Anacortes City Council
Municipal Building Council Chambers
**** This meeting will be held electronically only ****

October 5, 2020
6:00 p.m.

File Number:	CUP-2020-0001
Project Name:	1015 18 th St. Parking Lot CUP
Proposal Description:	New private parking lot located partially within the R4 zone and Commercial Zone.
Documents available at:	City Hall, Planning Community & Economic Development Department
Public hearing:	Anacortes Planning Commission
Public hearing date:	September 23, 2020
PC deliberations:	September 23, 2020
Decision Body:	Anacortes City Council
Closed Record Hearing Date:	October 5, 2020 @ 6:00 PM

Re: REVISED Conditional Use Permit (CUP-2020-0001) Narrative for 1015 18th St. Parking Lot;
P55166; PRE-2019-0028

2 SITE PLAN

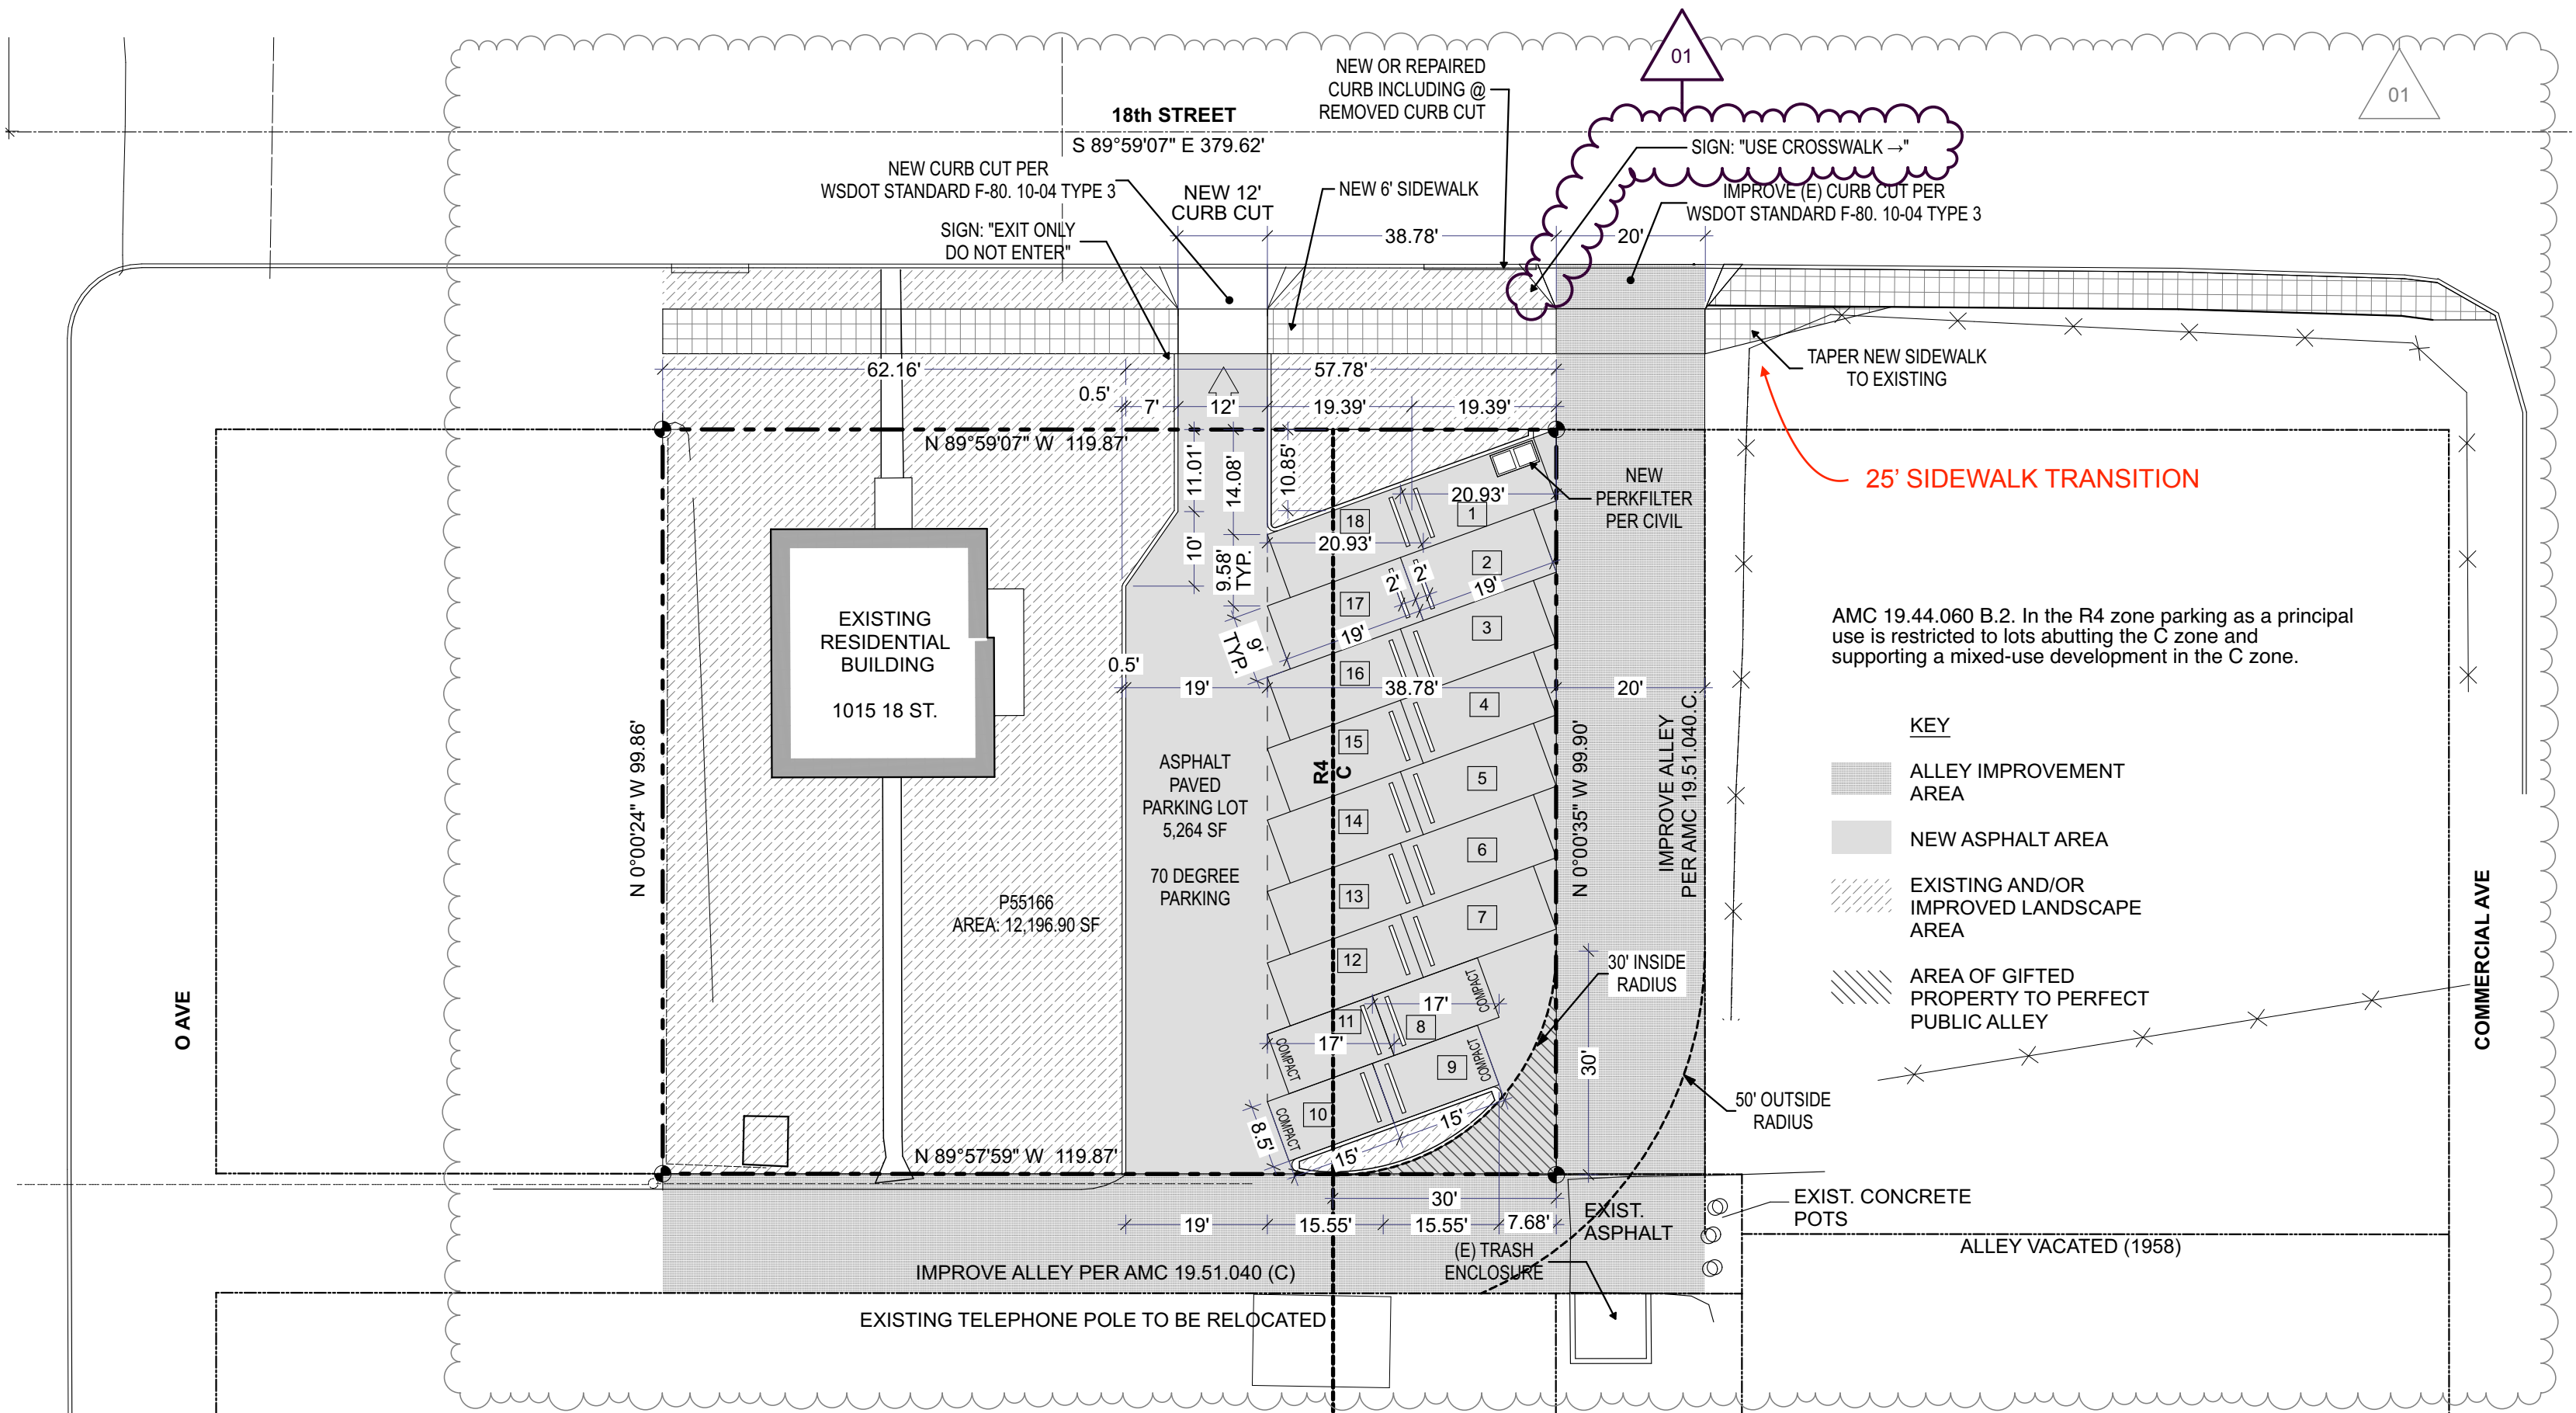
1. *Sidewalk transitions should be at a minimum of 25'.*
See A1.0/ 02 Site Plan for 25' sidewalk transition from new to existing sidewalks.
2. *Recommend a 6' winf on the curb transions.*
We elect to continue using a 5' curb transition per WSDOT Standard Plan F-80, 10-3 Type 3 Concrete Driveway entrance.

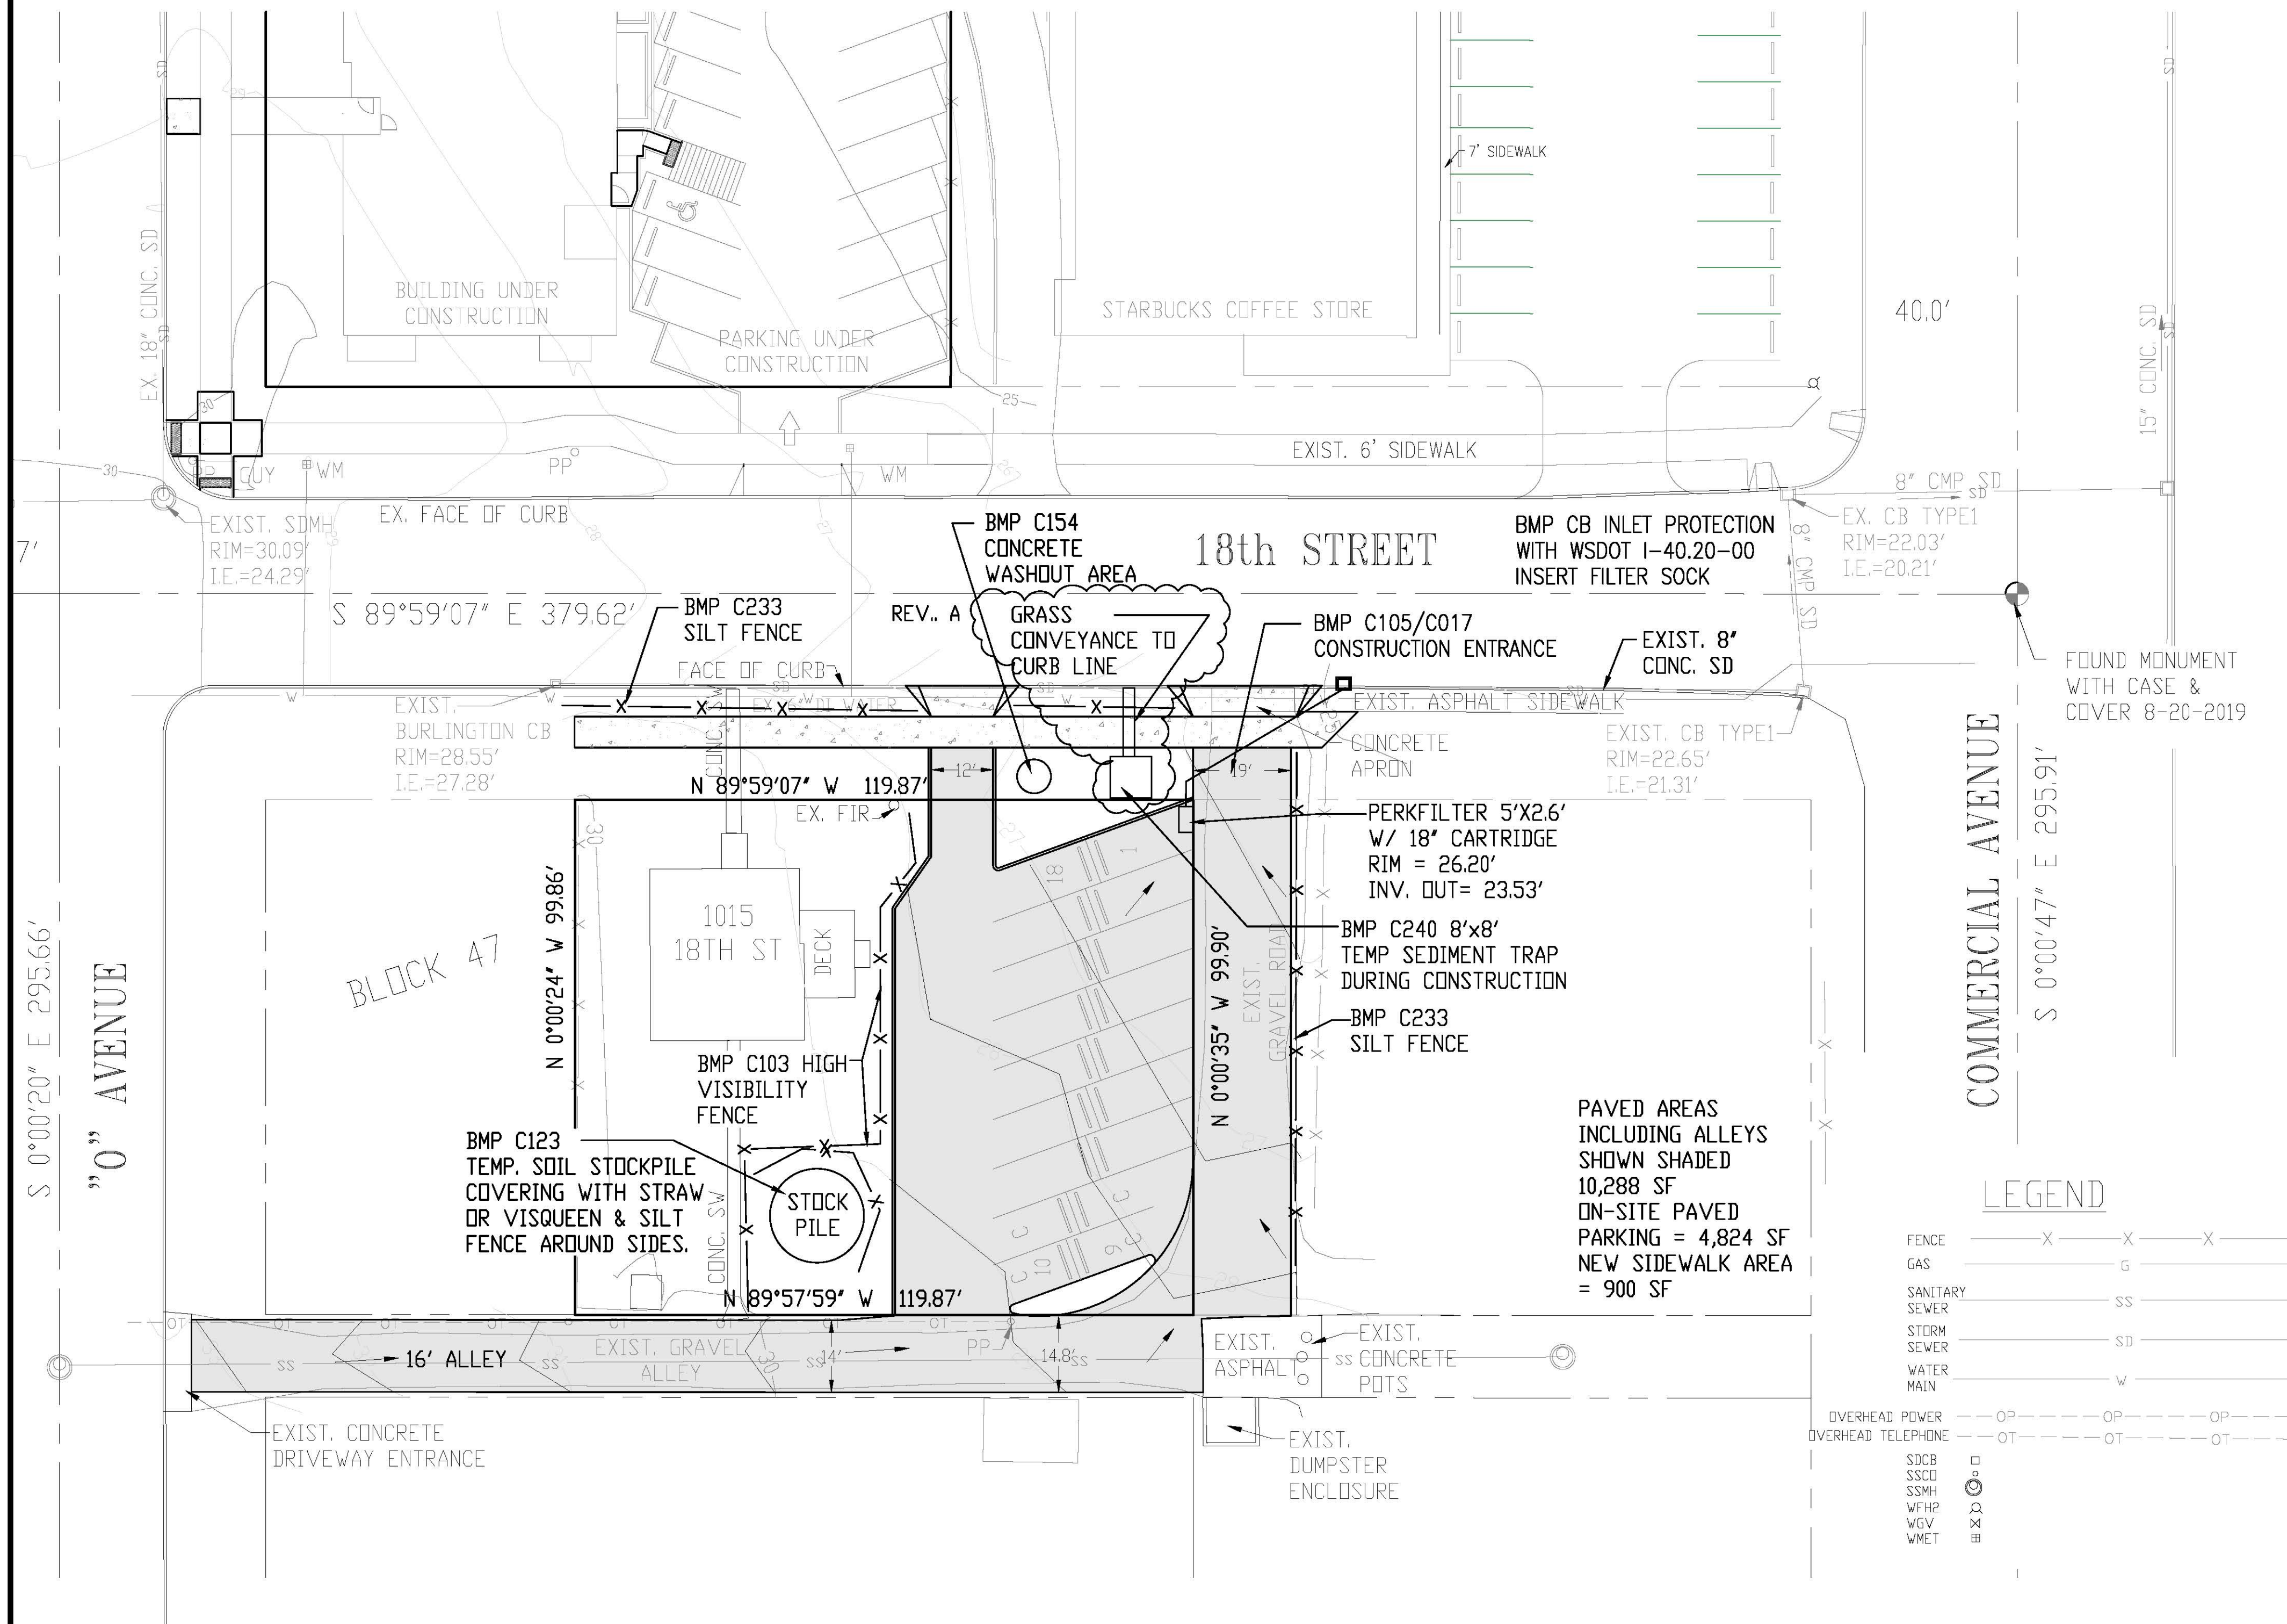
2. The temporary sediment trap discharge path to a stabilized conveyance system shall be shown on Sheet C3. The size of the sediment trap shall also be noted.

2. The temporary sediment trap discharge path to a stabilized conveyance system shall be shown on Sheet C3. The size of the sediment trap shall also be noted.
3. The PerkFilter shall tie into a structure connected to the existing storm drain along the south side of 18th Street.
4. The storm drain along the south side of 18th Street shall be labeled with the size and type of pipe.

2. The temporary sediment trap discharge path to a stabilized conveyance system shall be shown on Sheet C3. The size of the sediment trap shall also be noted.
3. The PerkFilter shall tie into a structure connected to the existing storm drain along the south side of 18th Street.
4. The storm drain along the south side of 18th Street shall be labeled with the size and type of pipe.
